Subject : Current Configurations of Pressure Suit and Parachute

The results of the meeting on January 16 thru 18 with regard to changes in the pressure suit and parachute are as follows:

FULL PRESSURE SUIT 1962
OXCART

10 A.

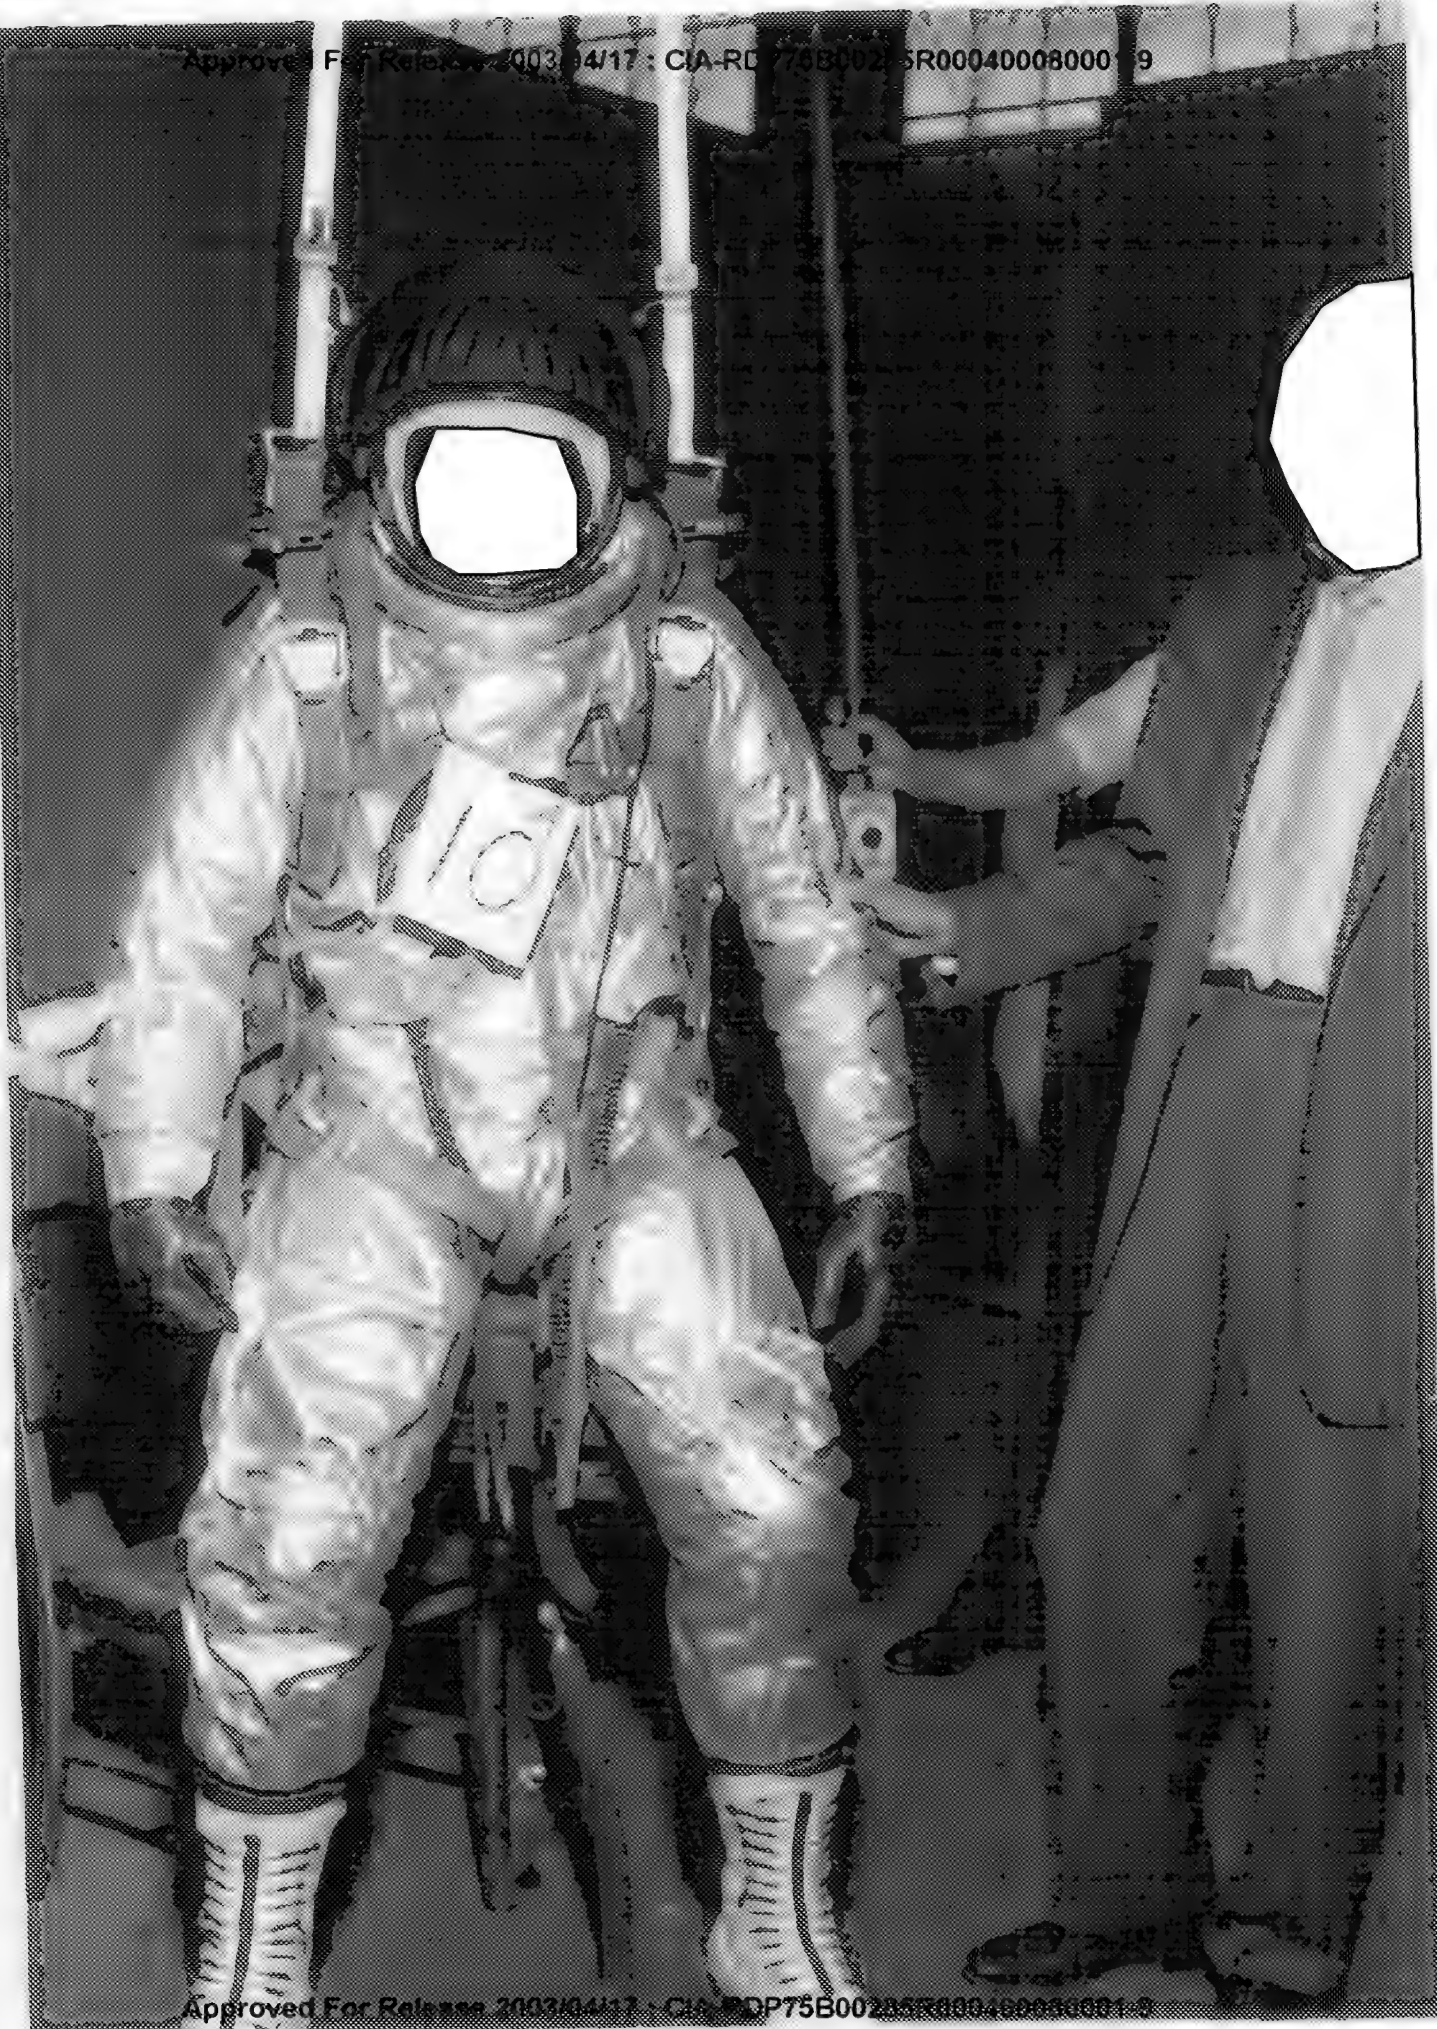
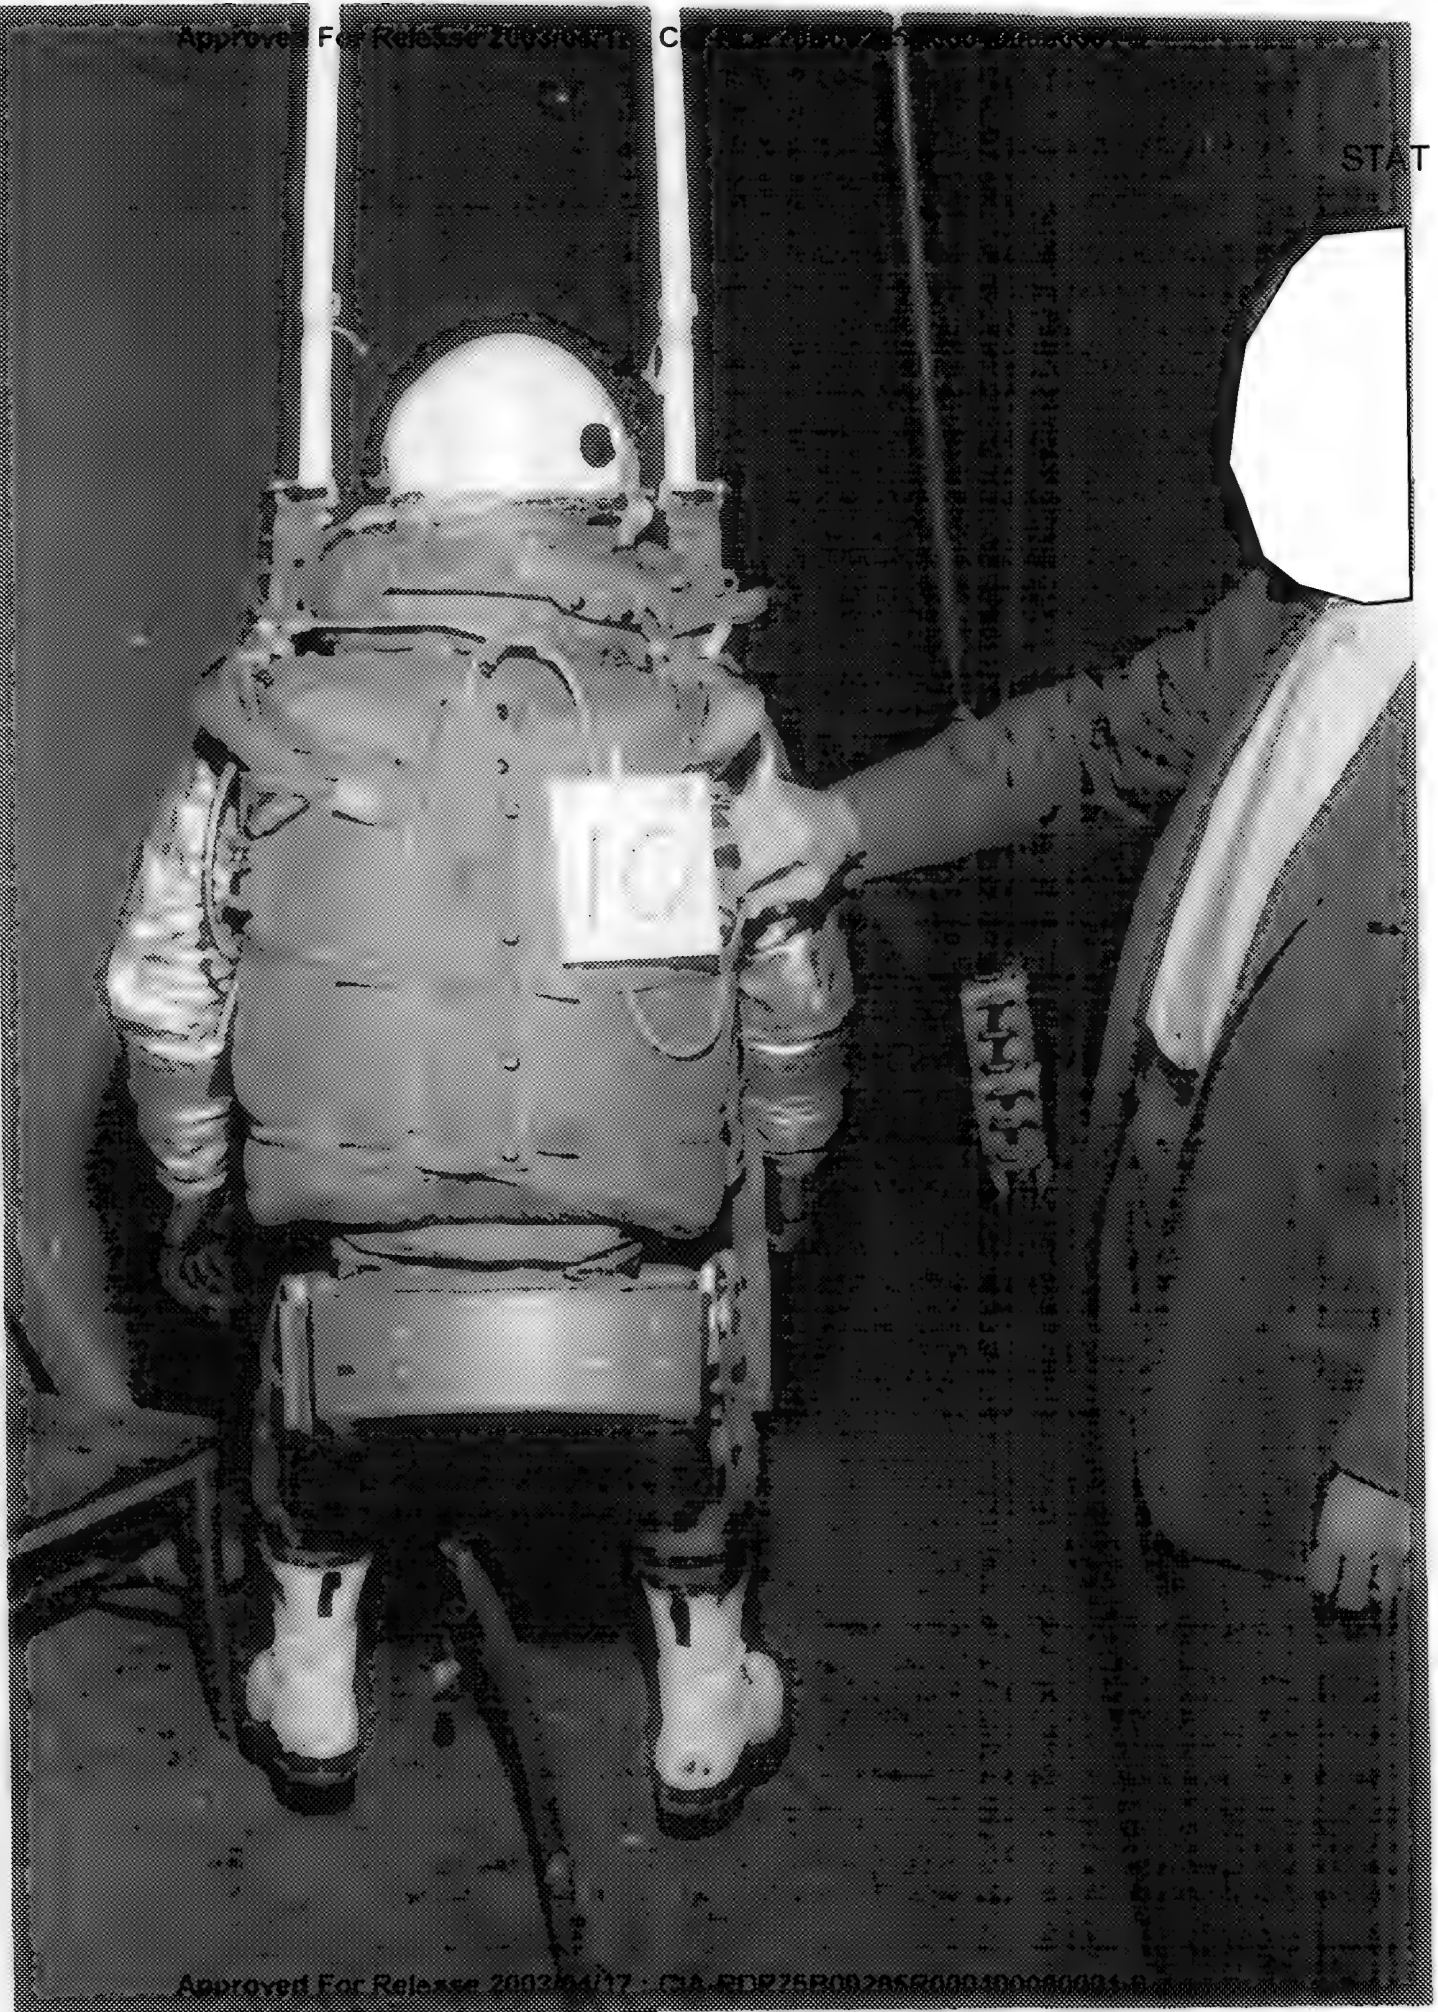
SAME RIG AS #10

a) COLLAR OUTSIDE NECK RING.

a) STILL UNCOMFORTABLE

b) DEFINITELY UNDESIRABLE

STATINTL
#12

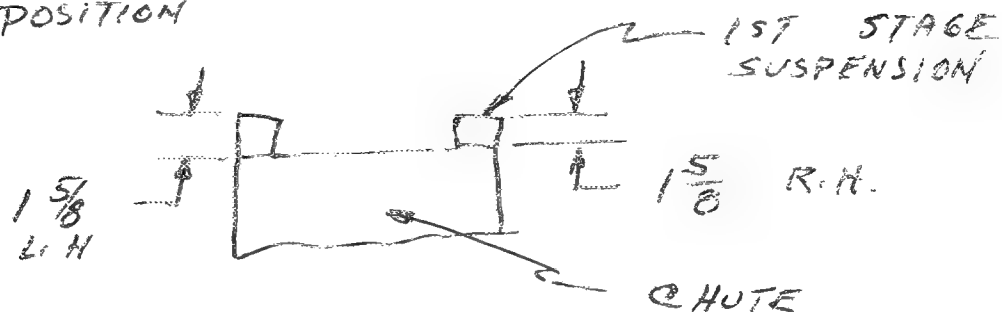
- a) SAME RIG AS #11
- b) SUSPENSION POINT IN AFT POSITION

- a) CONSIDERS MORE COMFORTABLE IN CHEST
- b) MORE COMFORTABLE ALL AROUND

THIS IS RIG THAT WAS CONSIDERED
ACCEPTABLE AND REVISIONS ARE BEING MADE
TO THIS CONFIGURATION.

#13

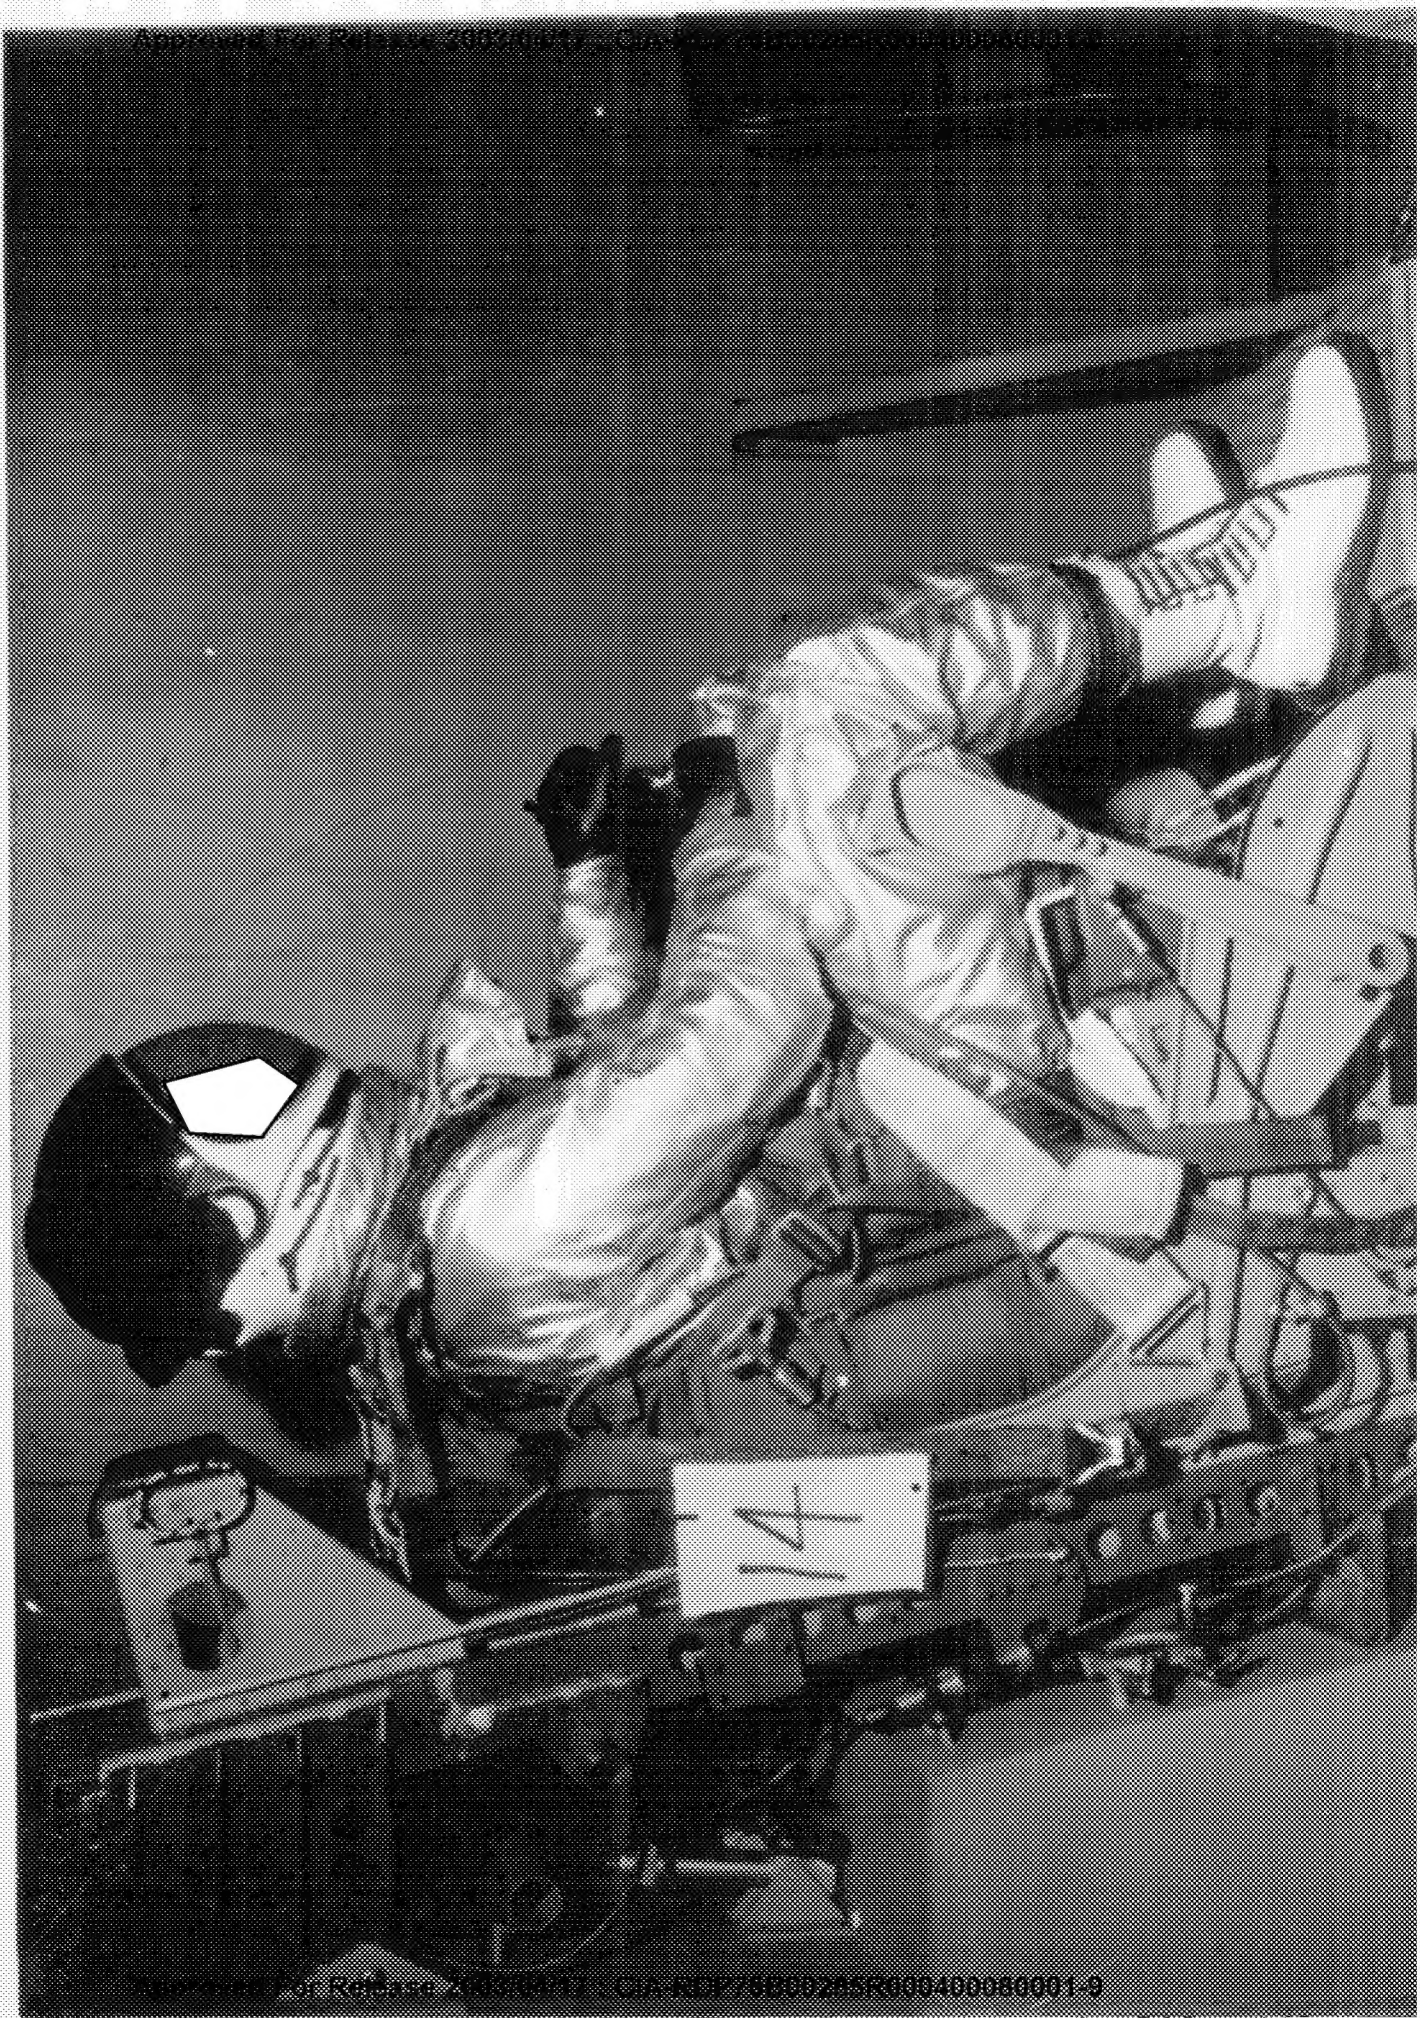
a) HEAD MOBILITY JUST A LITTLE
BETTER - VERY LITTLE DIFFERENCE

b) PRESSURIZED - ARM MOBILITY
REDUCED BUT NOT CRITICAL
HAS DIFFICULTY SEEING DOWN
AND FROM SIDE TO SIDE UNDER
PRESSURE

c) WITH HELMET STRAP PULLED
DOWN MOBILITY IMPROVED
